REPORT TO PLANNING COMMISSION City of Sacramento

Subject: Thai Basil Setback Variance (P11-027)

A request to reduce the required building street side setback in order to construct a second floor smoking porch with an area of approximately 309 square feet in the General Commercial zone within the Midtown Commercial Overlay (C-2-MC) zone and the Central City Design Review District.

Exhibit B-1 Proposed Site Plan and Elevations

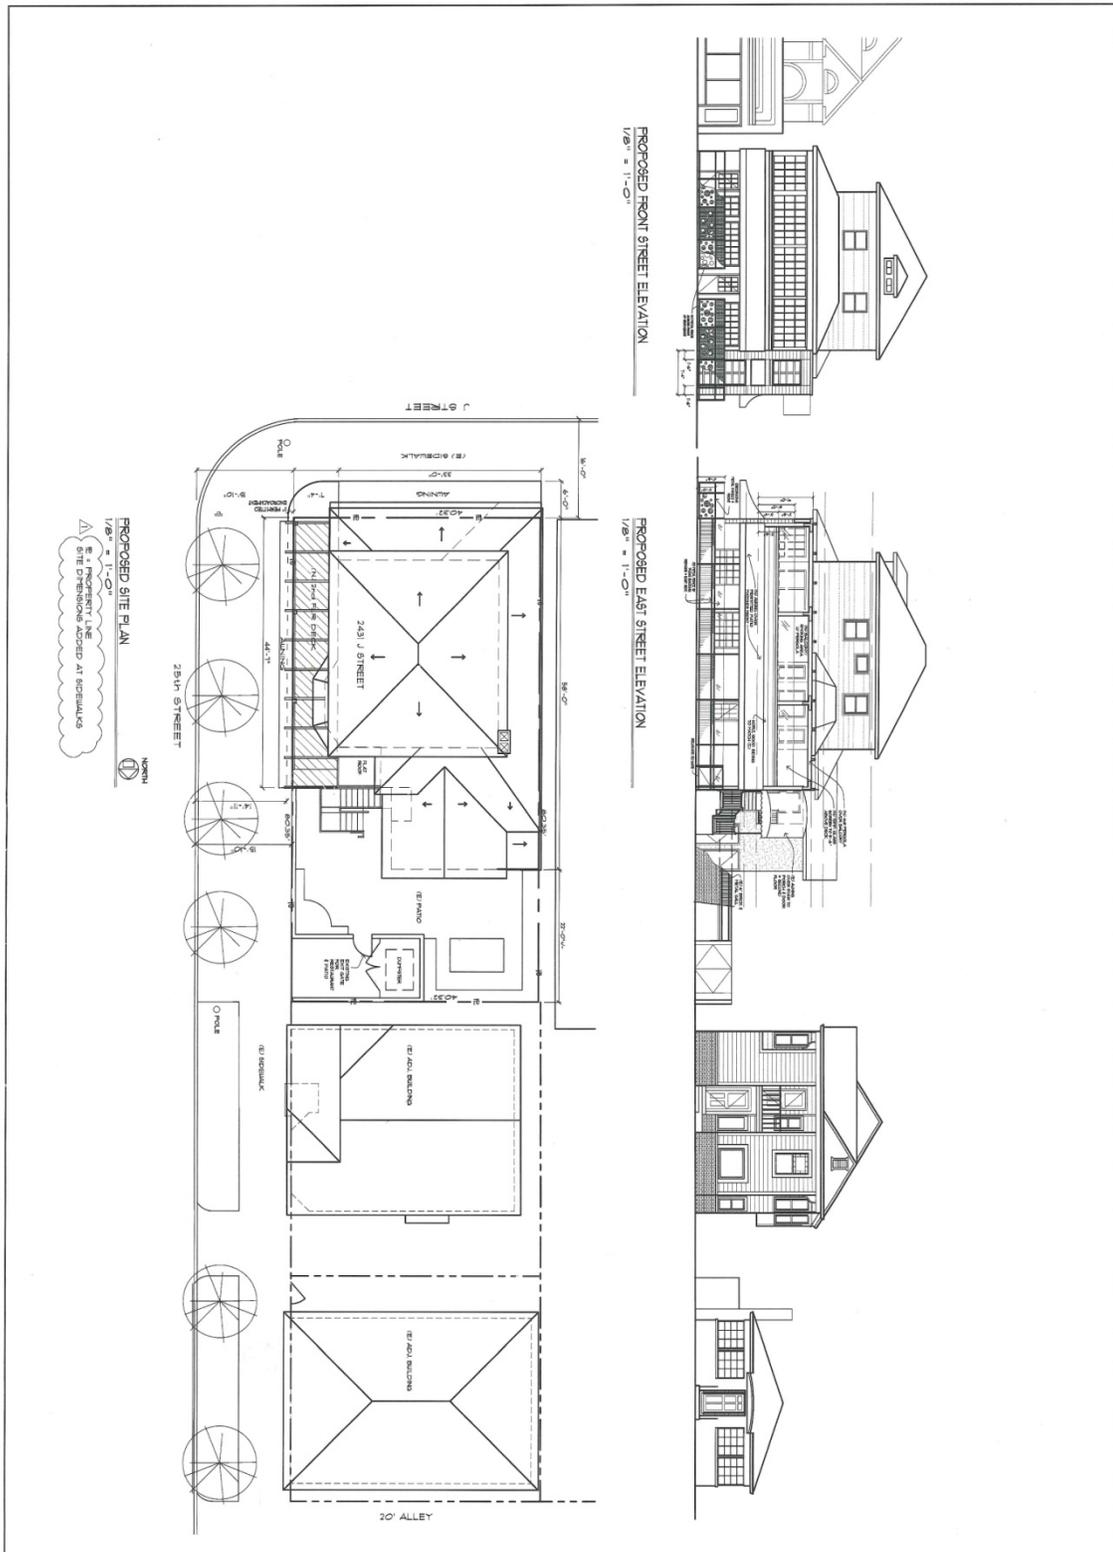
The applicant proposes to reduce the street side building setback from 5-feet to zero feet in order to construct the smoking porch above the existing outdoor café. As it is currently constructed, the outdoor café has no solid walls and is not considered to be part of the building thus the setback requirement has been maintained. The addition of the smoking porch, which will include solid building elements such as a floor and walls, is considered to be an extension of the building and as such must comply with the street side setback requirement of five (5) feet per Section 17.60.020, footnote 16.a.iv. of the Zoning Code. In order for the smoking porch to be constructed within the street side setback area, as proposed, a variance is needed per Section 17.216.010 of the Zoning Code.

The overarching building design will remain the same as currently exists save the second floor semi-enclosed smoking porch addition. A decorative screening element is proposed to connect the first and second level outdoor café and proposed smoking porch areas as an extension of the J Street façade. The smoking porch has been designed to echo the restaurant's unique design elements in both materials and architectural treatments. Because the project site is located in the Central City Design Review area, the porch addition was subject to staff level design review. Said review was approved on September 14, 2011, and is included as Attachment 2 of this report.

2. The smoking porch horizontal lap siding shall match existing siding per Sheet A3.
3. No portion of the smoking porch structure may extend beyond the property line including the screening wall along the J Street frontage.

4. The smoking porch pergola elements (colonnades, girders, cross rafters) shall be constructed of solid wood per the approved plans.
5. The two story screen wall shall be constructed per the approved plans with hardwood siding and recessed opaque glazing in a double row of lites with four rows of lites on the second level and seven rows of lites on the first level. The recessed lite frames shall match the screen hardwood siding.

Exhibit B-3 Existing and Proposed Second Floor Plans

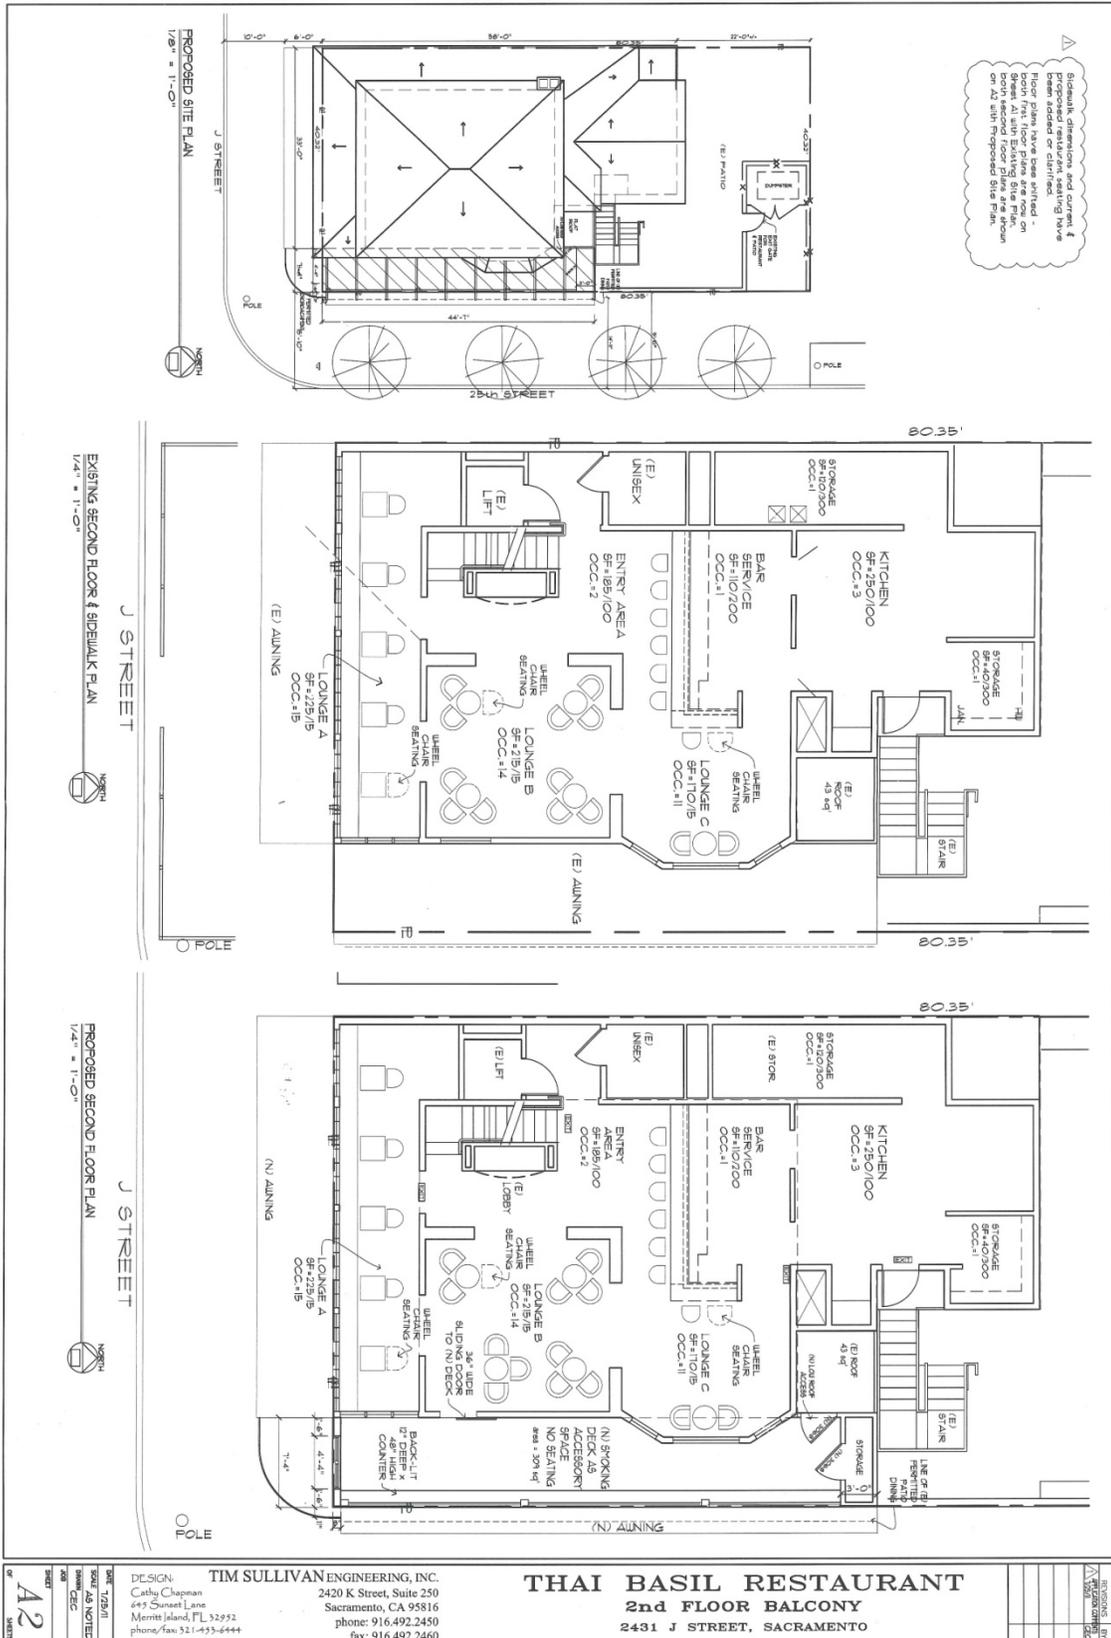
- B7. All work to comply with the 2010 California Building, Electrical, Mechanical, Plumbing, Fire and Energy Code.
- B8. Due to the increase in occupant load using a load factor of 5 square feet, an additional exit will be required from the second floor.
- B9. Accessibility improvements will be required as per California Building Code, section 1134B.
- B10. The minimum number of required plumbing fixtures for men and women must be met as per California Plumbing Code, Table 4-1.

Exhibit B-6 Thai Basil Sign Detail

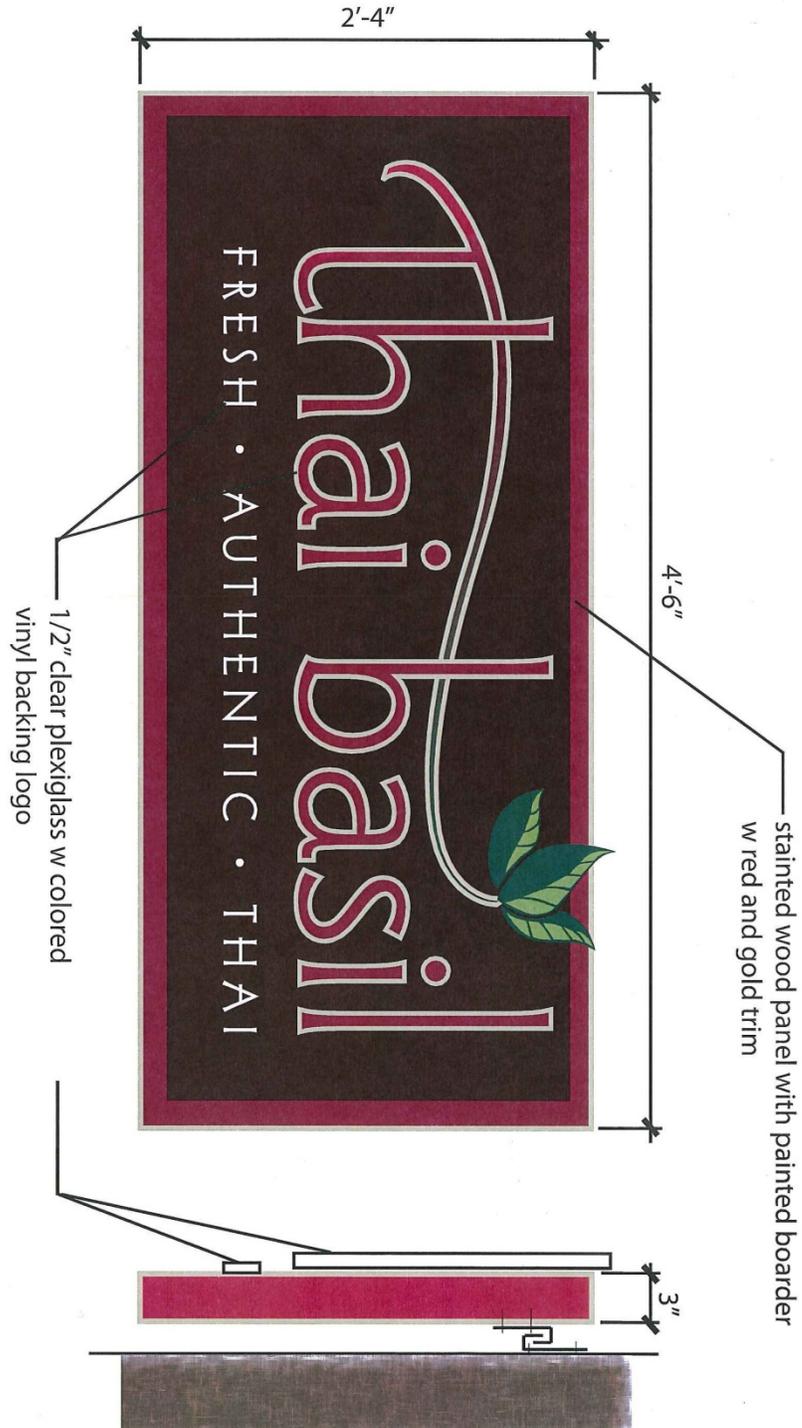
The applicant proposes to replace the existing attached J Street sign, currently somewhat obscured from view by the first and second floor awnings, with a new 10.5 square foot (4.5' x 2.33') attached sign. The sign would be located on the new J Street screening wall midway between the first and second floors. The sign would comprise a stained wood panel base with a color plexi-glass panel overlay of the new Thai Basil logo. The sign would be indirectly lit with a goose-neck spot light mounted above the sign, providing added dimension to the old-fashioned sign style. The sign detail is included as Exhibit B-6 of this report. The Planning Commission is not being asked to take action on the sign; review of the sign is being done at this time to help streamline the sign permit process for the applicant. The applicant is required to submit for a sign permit, where the sign design, size, and location will receive a final review.

8. Any new signage shall be submitted to design review staff for review and approval prior to issuance of any sign permit. Flat can signs are not allowed.
